PRODUCT/PROCESS CHANGE NOTICE (PCN)

PCN #: **N1701-01** Date: February 2, 2017
 Product Affected: 8V97051NLGI
 8V97051NLGI8
 8V97051NLGI/W
 Date Effective: May 2, 2017

Example of Prefix character change in datecode line

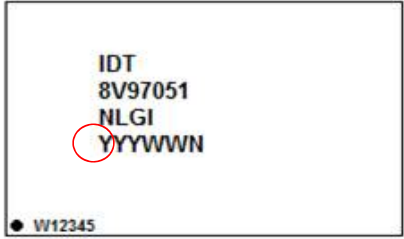
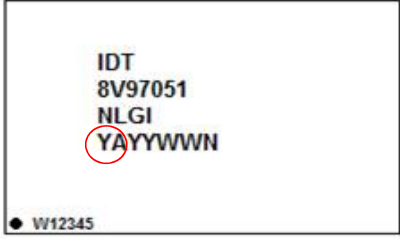
Detail of Change: The change improves device robustness for low temperature operation. On other similar devices, a circuit marginality may on rare occasions cause the device to power up in an undesirable state in low temperature environments. Pro-active measures to implement the same resolution on this device, which uses a similar circuit, have been taken. The failing power-up condition would potentially be seen at cold temperature as for other similar devices even though none has been observed so far. Possible failure modes related to this potential low temperature fault include: no output switching, switching at an incorrect frequency, no access to the registers, and wrong configuration in the digital PLL blocks. While the probability of this fault being manifest in the current design is low, the above mentioned design change will completely eliminate the possibility of this fault occurring.

From: Y	To: YA
 <p>IDT 8V97051 NLGI YYYWWN</p> <p>● W12345</p>	 <p>IDT 8V97051 NLGI YAYYWWN</p> <p>● W12345</p>
